DATE: March 14, 2018

TO: Design Review Commission
FROM: Sunny Chao, Associate Planner
SUBJECT: 17-SC-34 – 1460 Oakhurst Avenue

Re: 1460 Oakhurst Design Review #2 (1-Story Design)

PRIVACY DIAGRAM

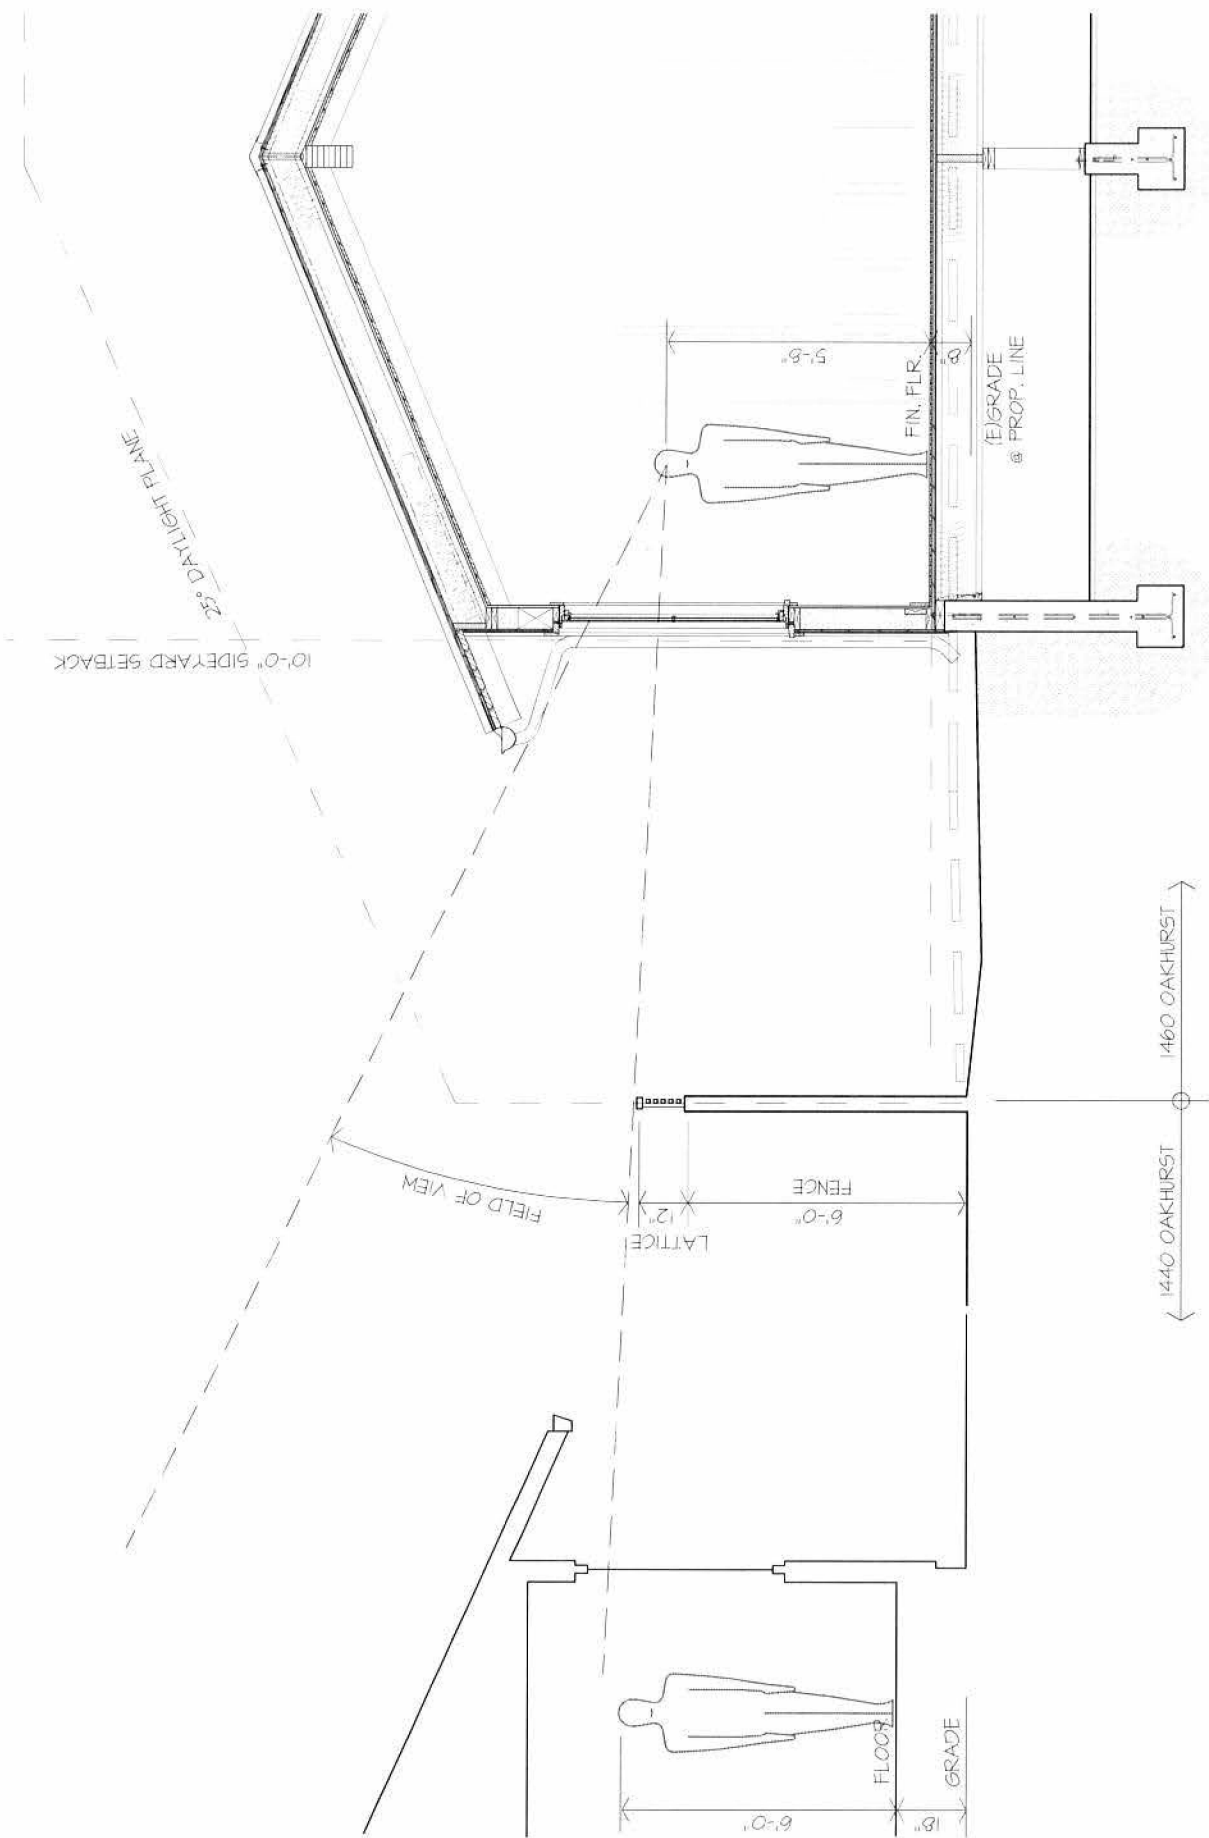
1) Reducing maximum floor height to less than 22" above existing and finished grades:

We have lowered the finish floor elevation 19" relative to existing grade, to 216.37 ft., making the maximum finished floor height above existing grade 6 1/2" (measured at the Northwest corner of the bedroom wing, where the existing grade = 215.75). The final grading at the foundations has been lowered to 215.33 ft, 12 1/2" below finished floor.

Please note we will also be sharing the expense of a new 6'-0" fence with 12" lattice with the neighbor to the North (at 1440 Oakhurst). Please see attached privacy diagram.
